RE: North Bride Brook Multi-Family Development  
East Lyme, CT

## COMMENT RESPONSE SUMMARY

## COMMENT RESPONSE SUMMARY

**RE:** North Bride Brook Multi-Family Development, Wetlands Application Review

## POND-01 Stage 2

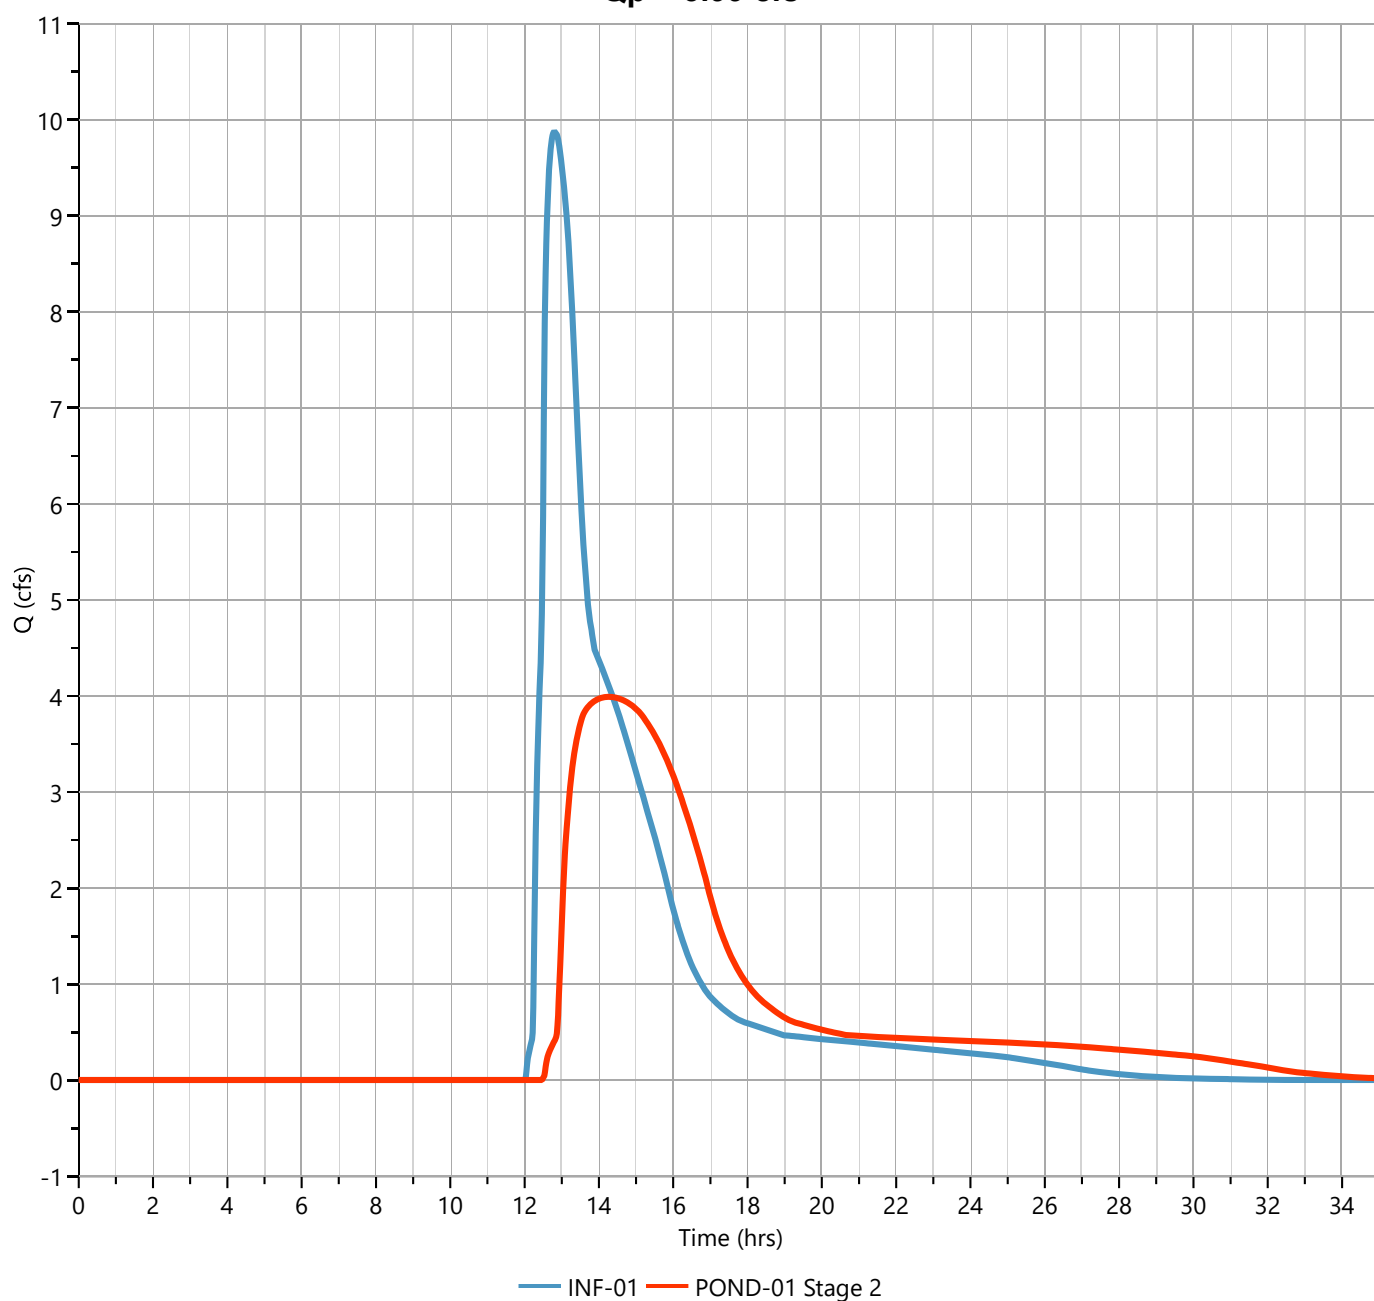
5. The Stormwater Management Report shall include information verifying the drain down time in the Detention Basin following a rain event and the field measured infiltration rate in the area

of the Detention Basin. The Detention Basin should completely dewater between storms and a practical lower infiltration limit of 0.3 inches per hour is recommended; refer to Section 11-P3-8 of the 2004 Connecticut Stormwater Quality Manual by CT DEEP.

It is our opinion that the exfiltration rates used in the original analysis are appropriate. As a conservative measure, the detention pond (stage 2) was run with an exfiltration rate of 0.3 inches per hour to confirm the drain time should surficial soil conditions restrict exfiltration. Under these conditions, the pond will drain in less than 36 hours and it should be noted that the system will still result in zero net increase in peak flow rates.

NORTH BRIDE BROOK  
MULTI-FAMILY DEVELOPMENT  
PREPARED FOR  
PAZZ & CONSTRUCTION, LLC  
EROSION & SEDIMENTATION CONTROL PLAN

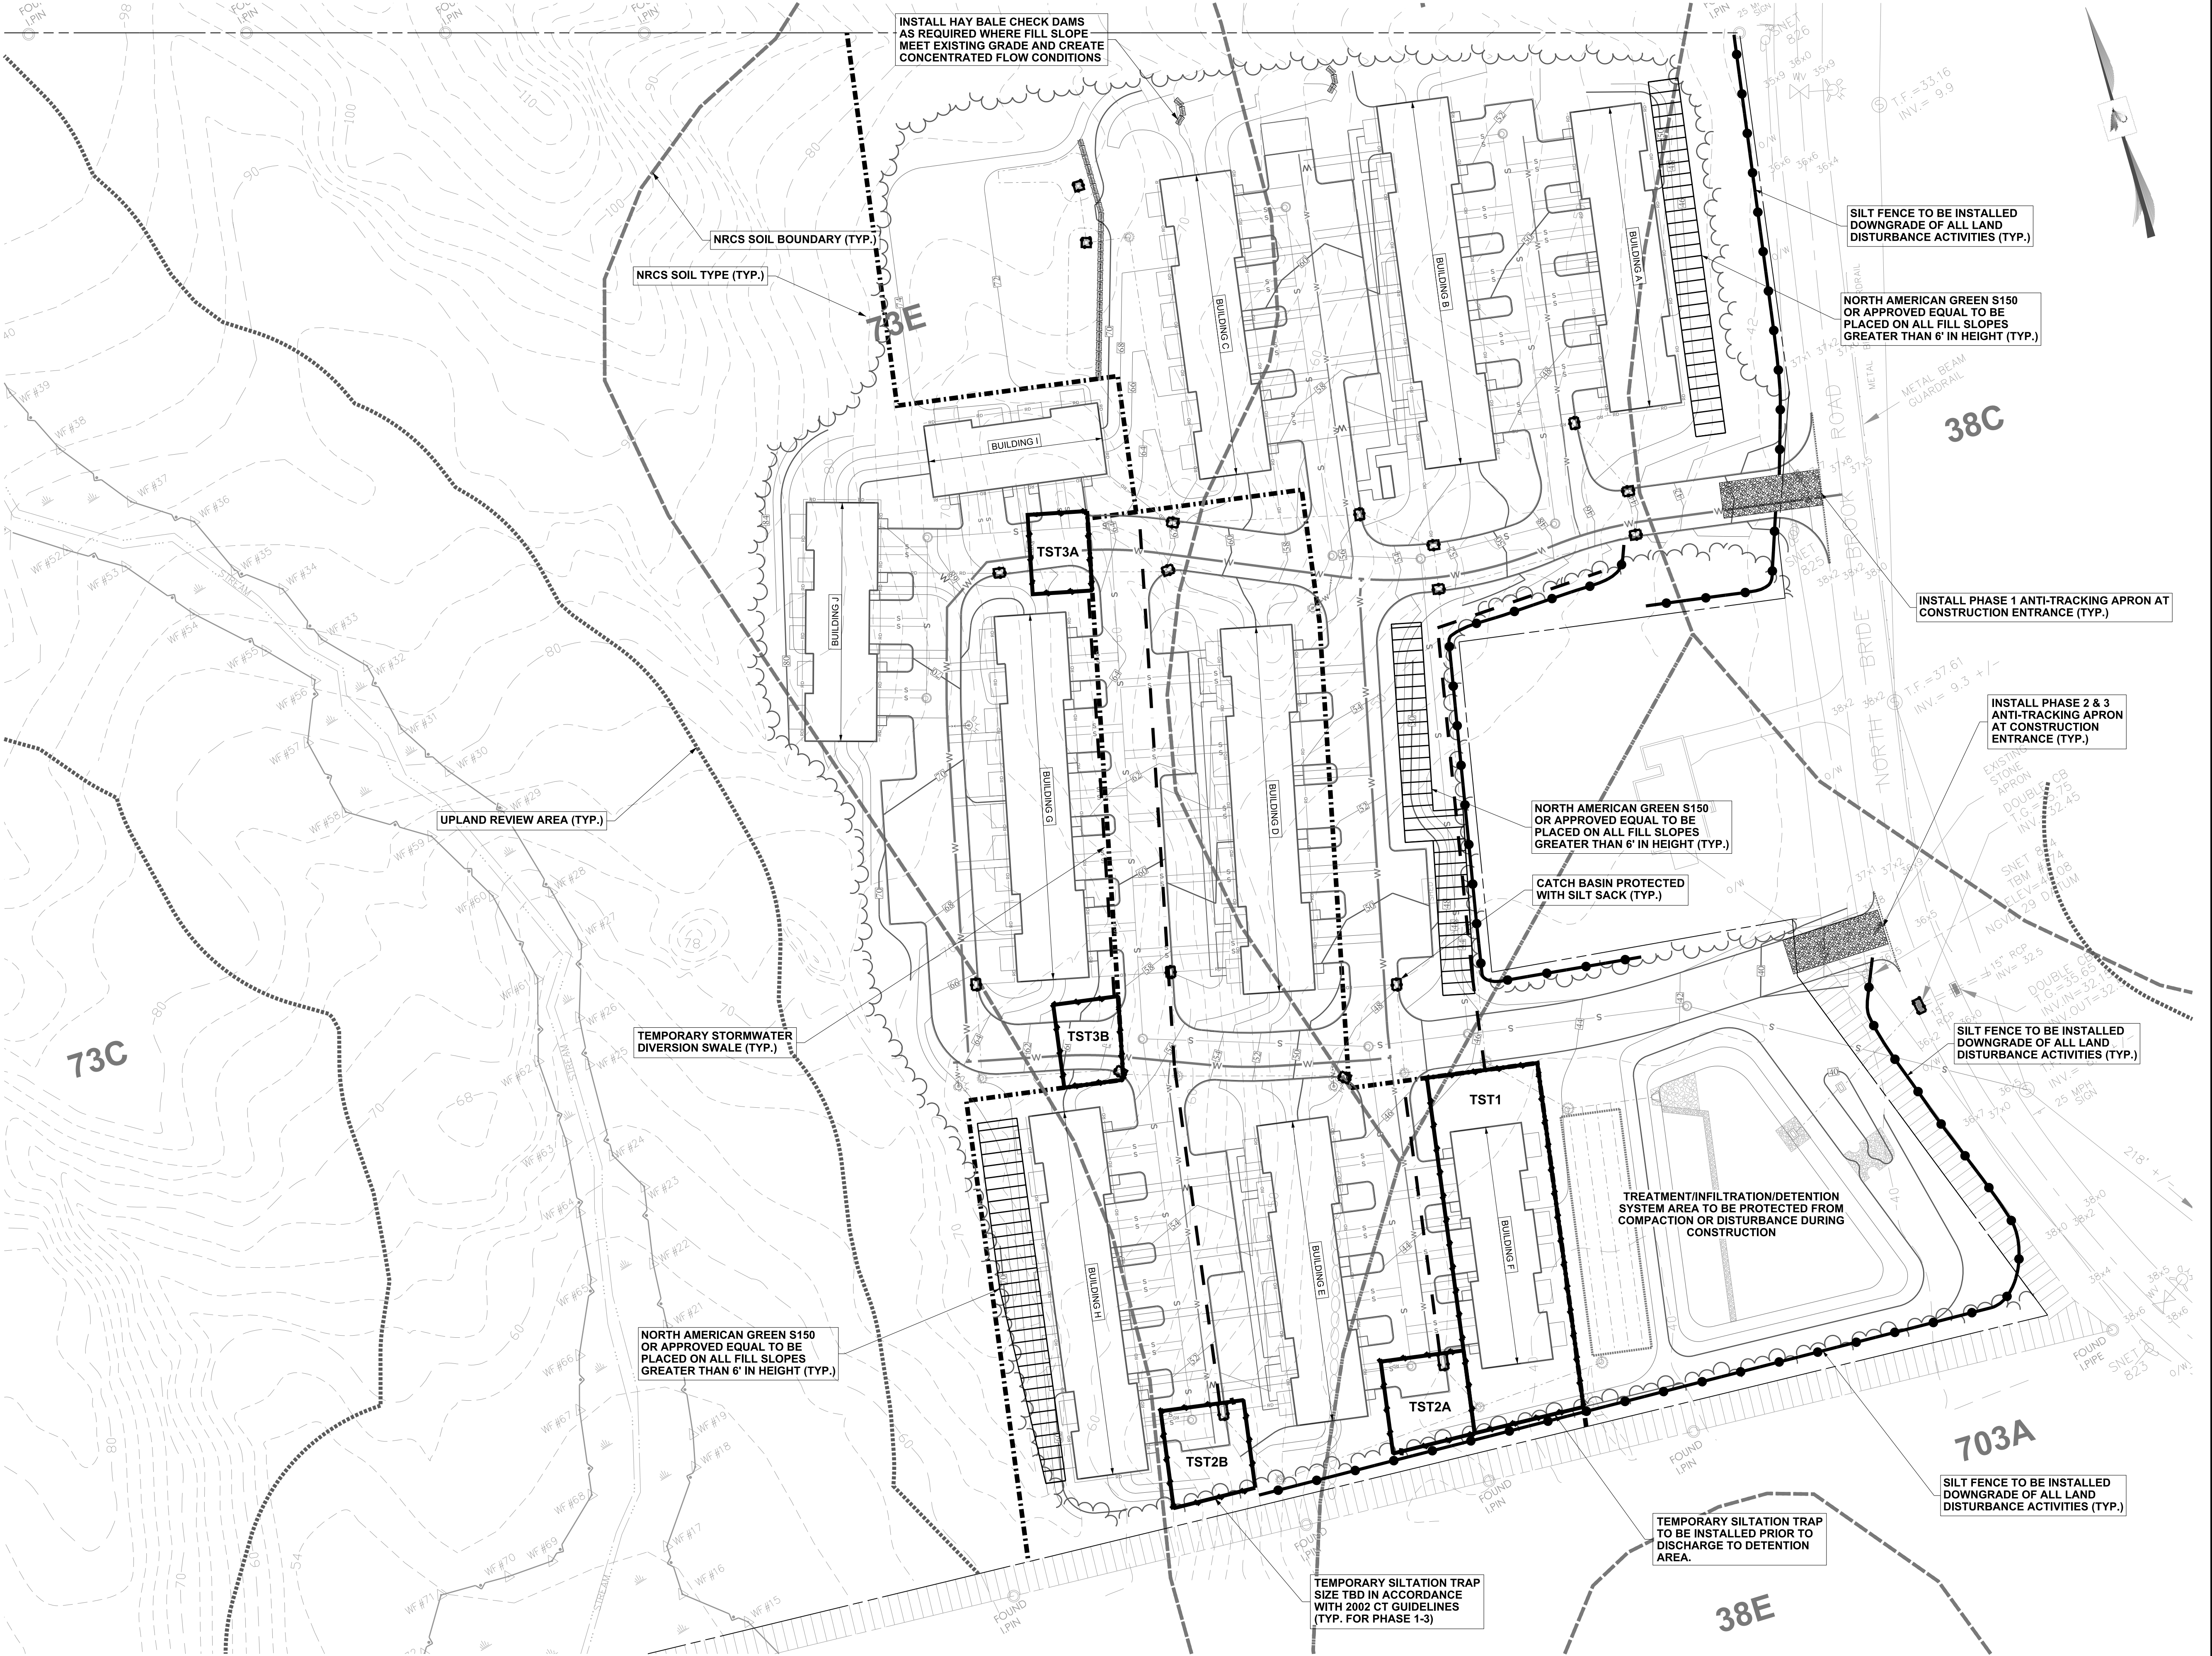
13. The Erosion & Sedimentation Control Plan (Sheet 5 of 8) and the Details (sheet 6 & 7 of 8) provide compliance with the 2002 Connecticut Guidelines for Soil Erosion and Sediment Control. The Sequence of Construction and E&S Narrative notes propose the project to be completed in multiple phases; Inspection and Maintenance notes along with Temporary Sediment Trap sizing and detail have also been included.

**Response.** Noted.

**TYPE "C", "CL" OR "CG" STANDARD CATCH BASIN**

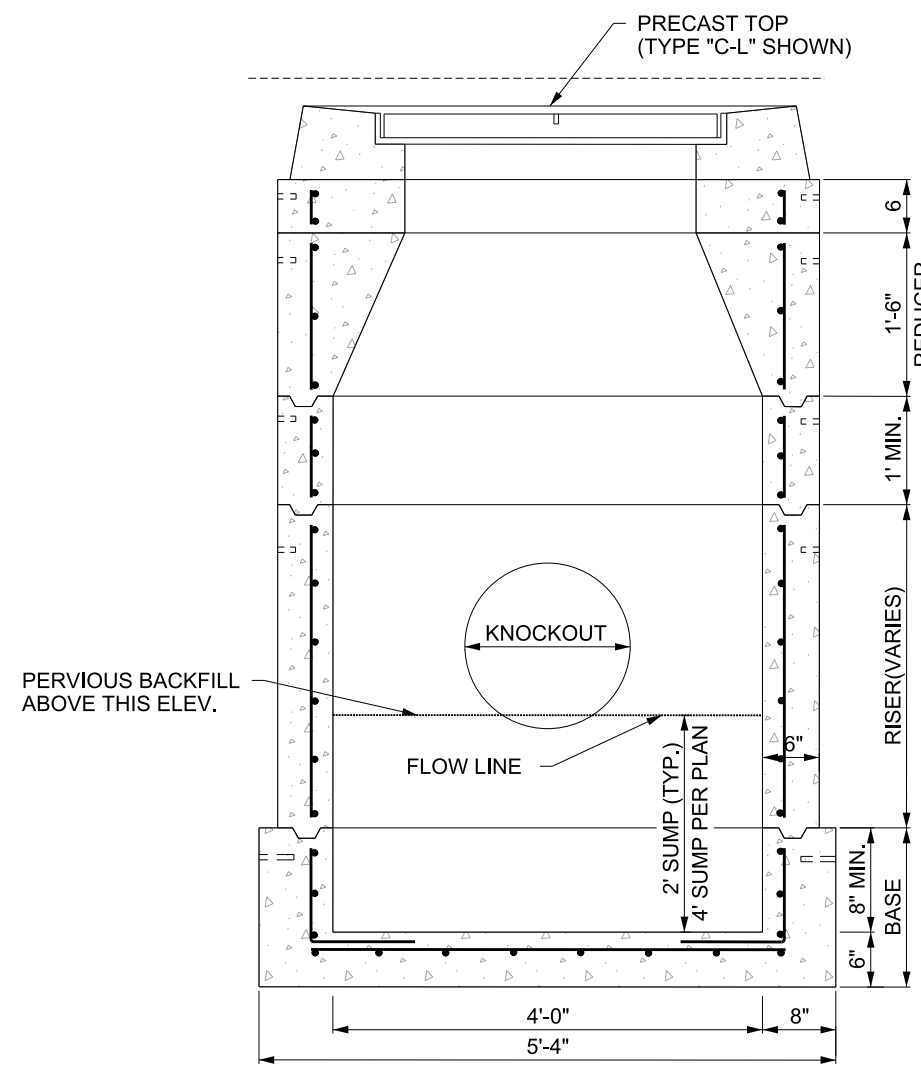
3. Provide note on Grading & Drainage Plan (Sheet 3 of 8) indicating 4' deep sumps at proposed catch basin #'s 101, 102, 206 & 215; update Standard Catch Basin detail (Sheet 7 of 8)

**Response.** The labels for catch basins 101, 206 and 215 have been revised to require 4' sumps. Outlet control structure 102 has not been revised. I recommend a minimal sump in the outlet control structure for ease of inspection and maintenance without a 4' deep pool of water.

**FILTER BED / RAIN GARDEN SECTION**

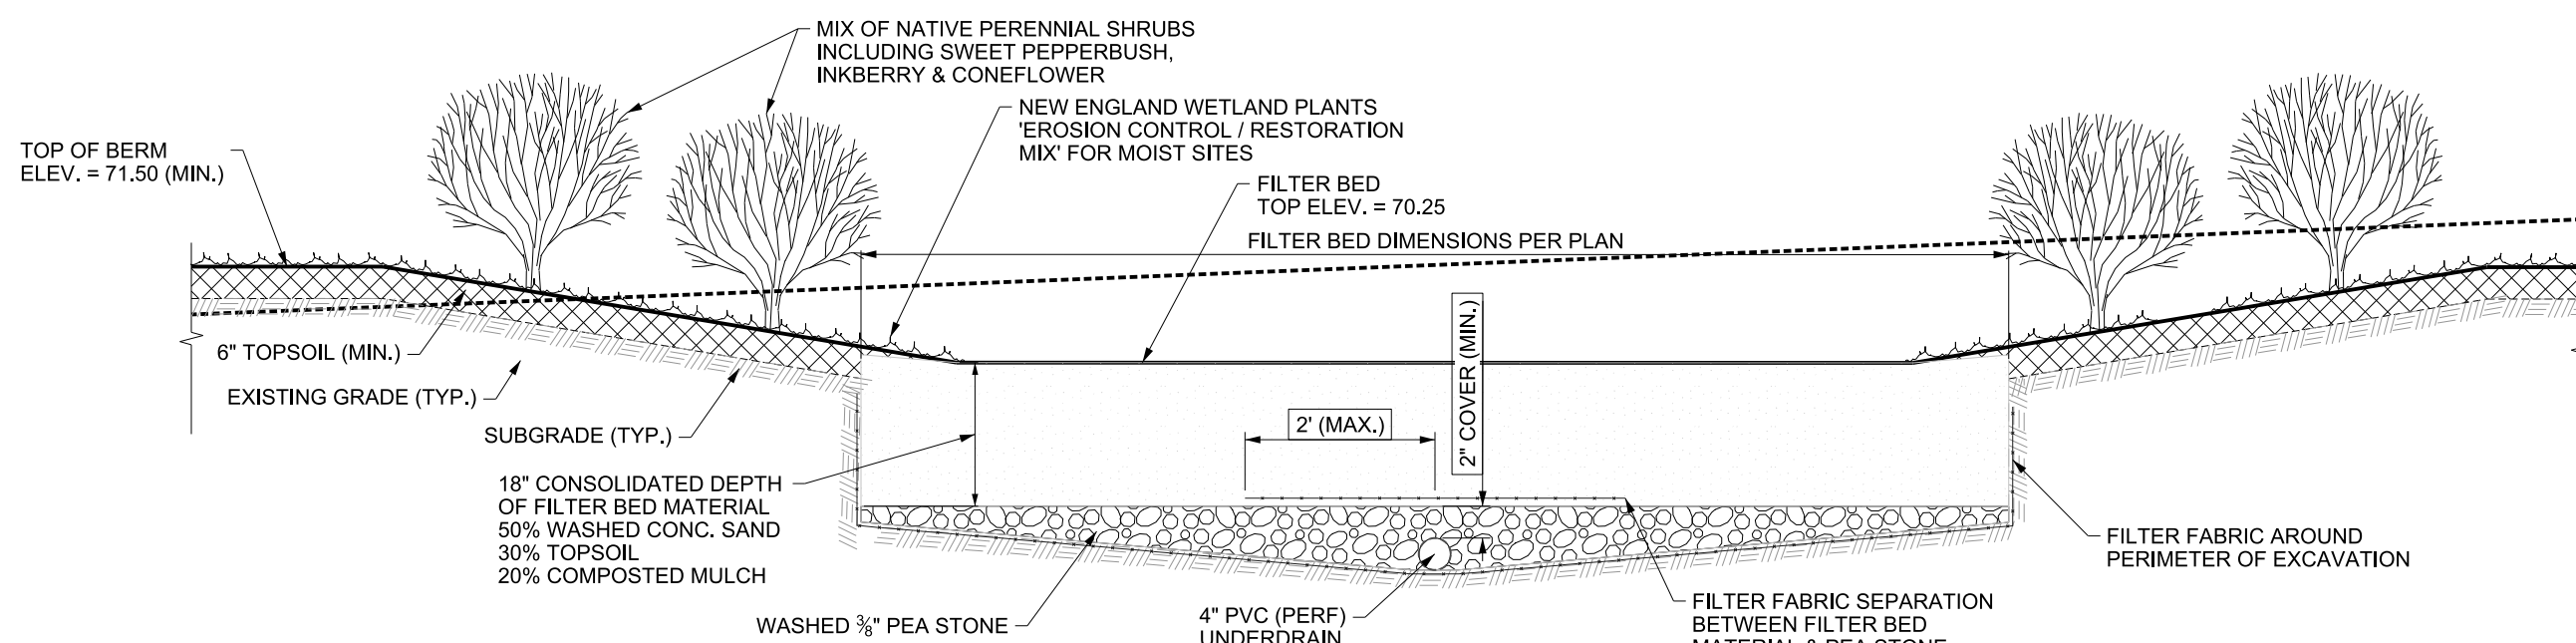
6. Provide Rain Garden installation notes, detail & short/long-term maintenance schedule.

**Response.** A filter bed / rain garden section detail has been added to Sheet 7 and installation and maintenance notes have been added to Sheet 3.
